RESOLUTION NO. 2012-08

**A RESOLUTION OF THE PLANNING COMMISSION OF THE CITY OF LEMOORE
RECOMMENDED CITY COUNCIL APPROVAL OF A MITIGATED NEGATIVE DECLARATION #2012-03/
ZONE CHANGE 2012-02/ SPECIAL ZONE EXCEPTION #2012-01/ CONDITIONAL USE PERMIT
#2012-01/ SITE PLAN REVIEW #2012-02/ APPLICATIONS BY MONTRIO CAPITAL PARTNERS TO
CONSTRUCT UP TO 184 MULTI-FAMILY GATED COMMUNITY COMPLEX**

Redlined Site Plan

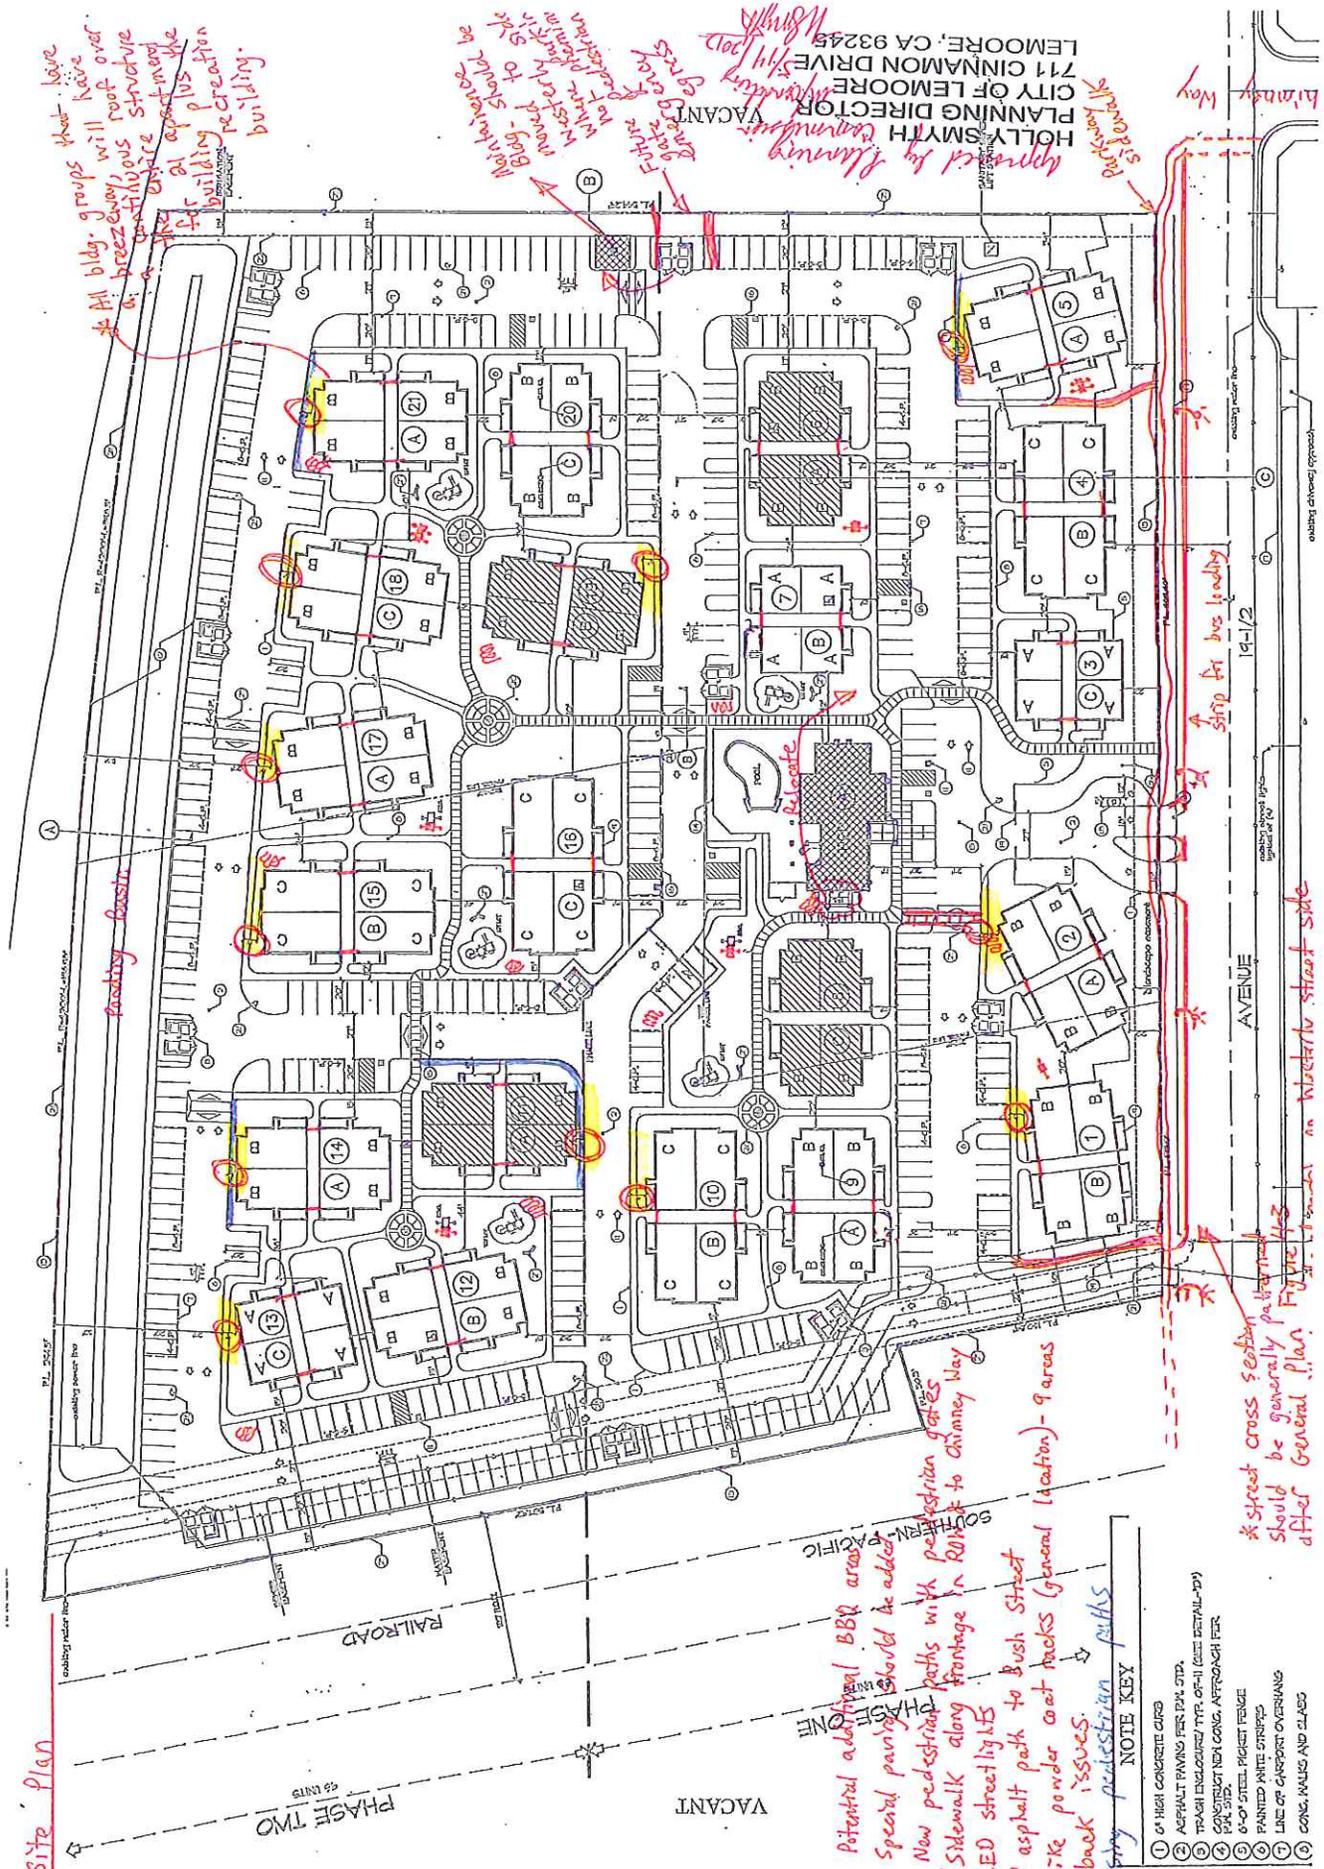
All bldg. groups that have breezeway will roof over. Consistuous structure at entire apartment building plus the building recreation building.

Approved by Planning Director Holly Smyth, City of Lemoore, CA 93245. 711 CINNAMON DRIVE LEMOORE, CA 93245. 1/8/12. Vacant. Future parking structure to be located in vicinity of Kinross Way. Entrance to parking structure should be located at Kinross Way.

* Street cross section should be generally parallel to General Plan. Figure 14-2. 14-1/2. Strip for bus loading. AVENUE 14-1/2. Kinross Way. existing driveway approach.

Red lined Elevations

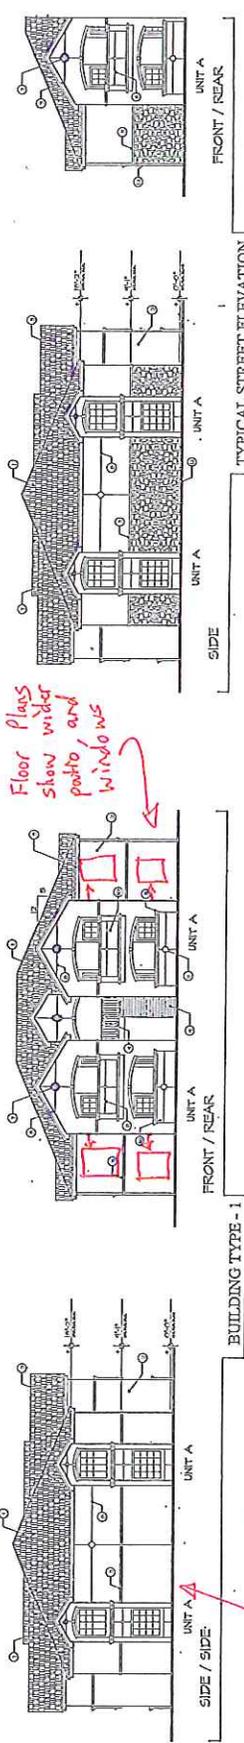
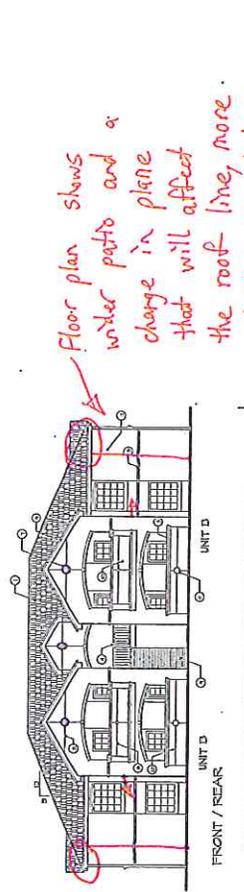
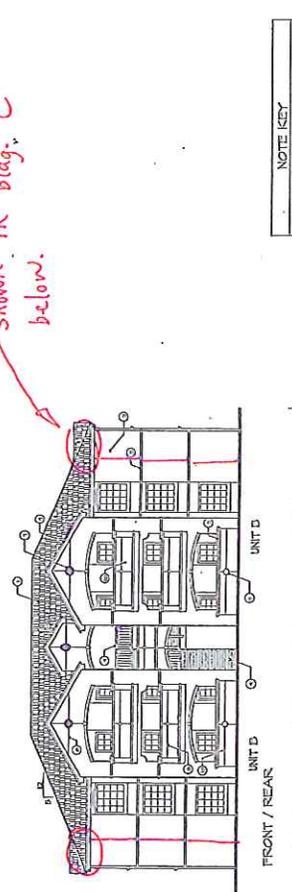
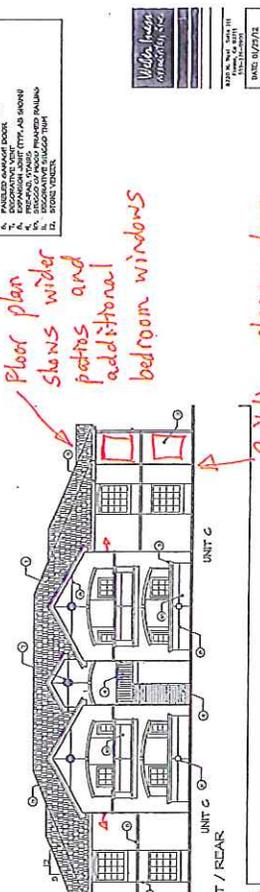
May have fire code issue on building #13 with less than 20' building separation.

Floor Plans show wider patio, and windows

Floor plan shows wider patio and a change in plane that will affect the roof line, more similar to what is shown in bldg. C below.

Floor plan shows wider patios and additional bedroom windows

Floor plan shows these window sets closer to one another.

Building plane does not change on floor plan

FLOOR PLANS

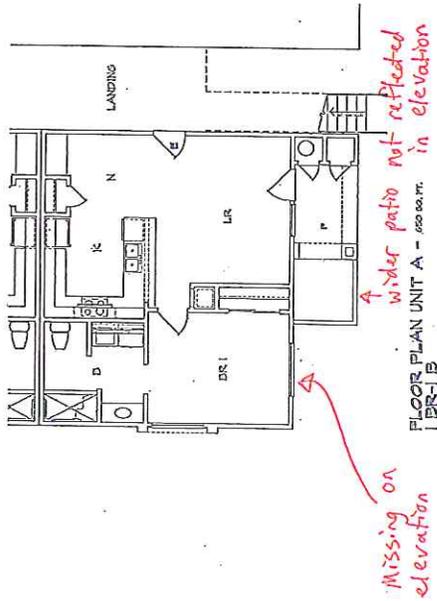
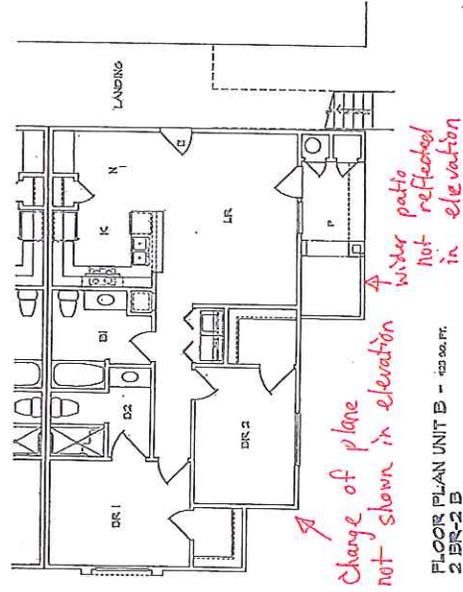
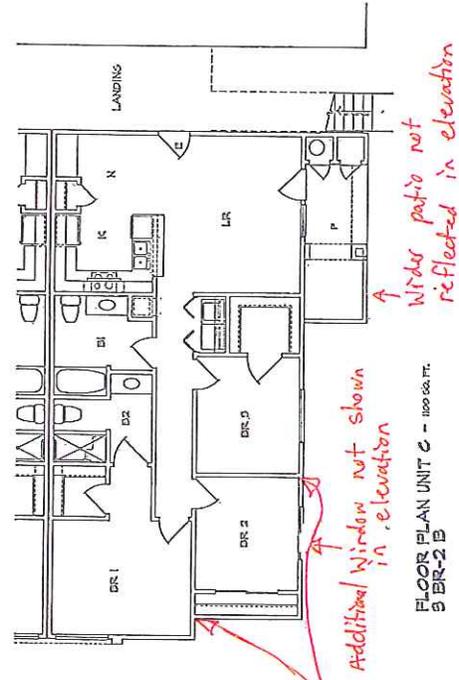
↑ wider patio not reflected in elevation

↑ wider patio not reflected in elevation

↑ wider patio not reflected in elevation

Elevation Shows change in building here instead of outside area

Sh/1/2012 Revised drawings to come back for approval
for Planning Commission
for separate approval
Holly Smyth
PLANNING DIRECTOR
CITY OF LEMORE
711 CINNAMON DRIVE
LEMORE, CA 93245
